IFB #2023-39

Northview Midrise Underground Water Storage Tank

ADDENDUM NO. #1

Sheet No.
C554
Project #2040

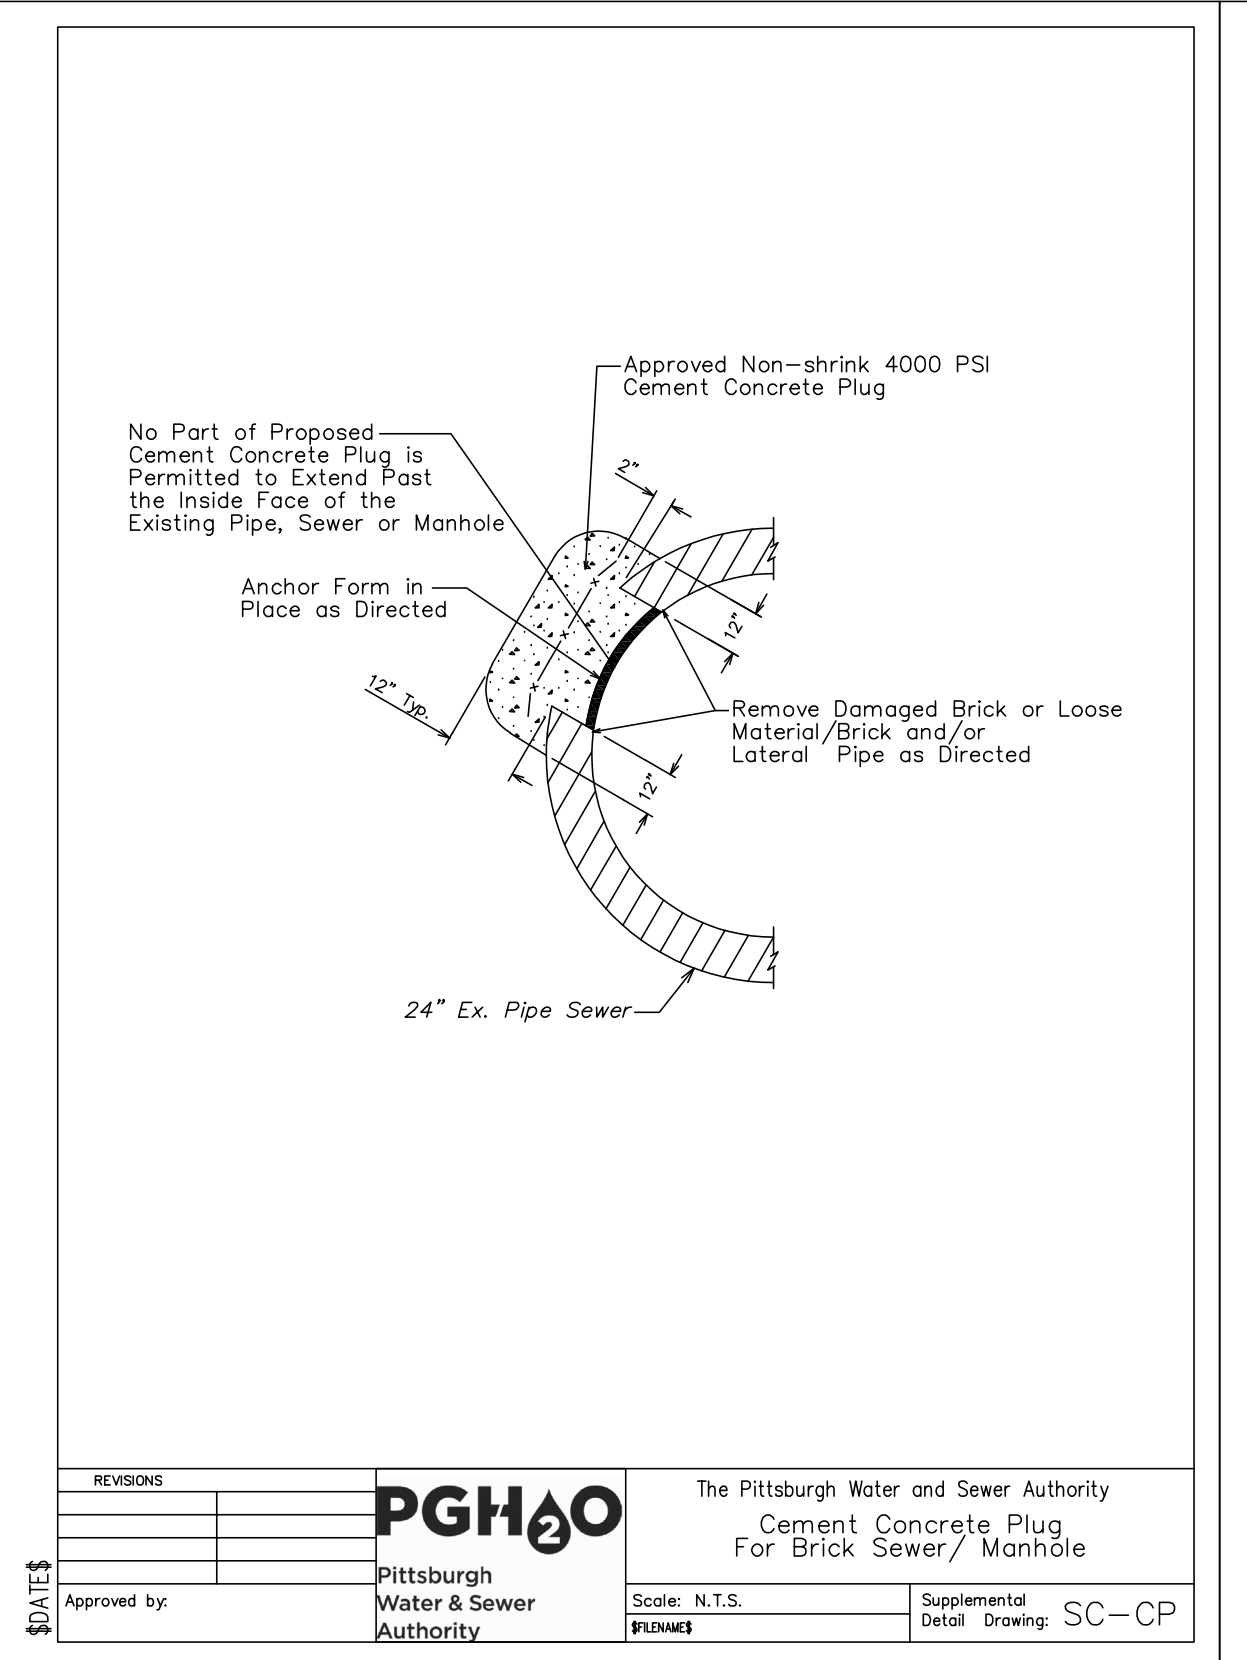
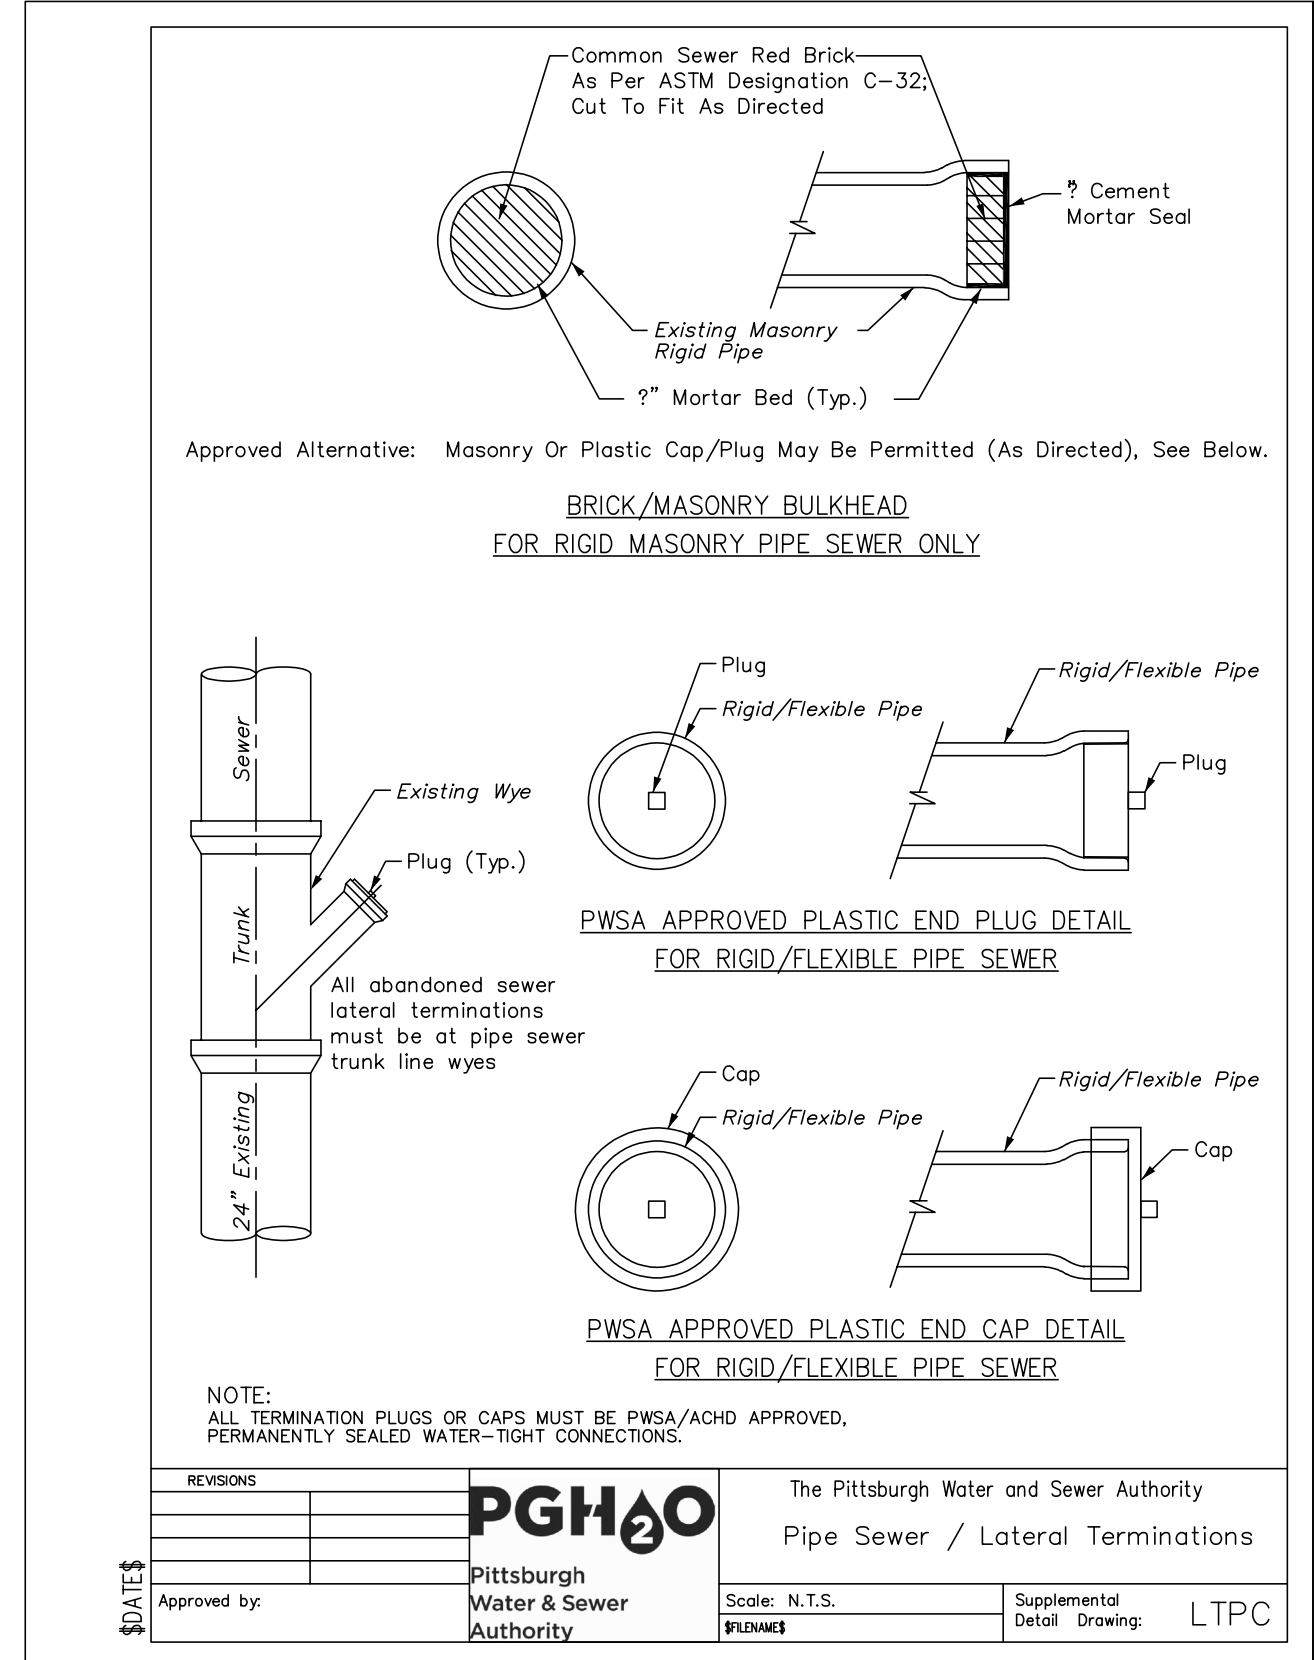
Item 3: The meter vault and water lines to the meter vault and storage tank have been relocated. Dimensional information for the meter vault has also been include along with minor revisions as noted as "Rev. 17". Attached are the revised sheets, C300, C400, C500, C552, C553, C554. C600. Please see Attachment A – Specifications Table of Contents and Section 33 16 00 and Attachment B – Civil Drawings for the aforementioned information.
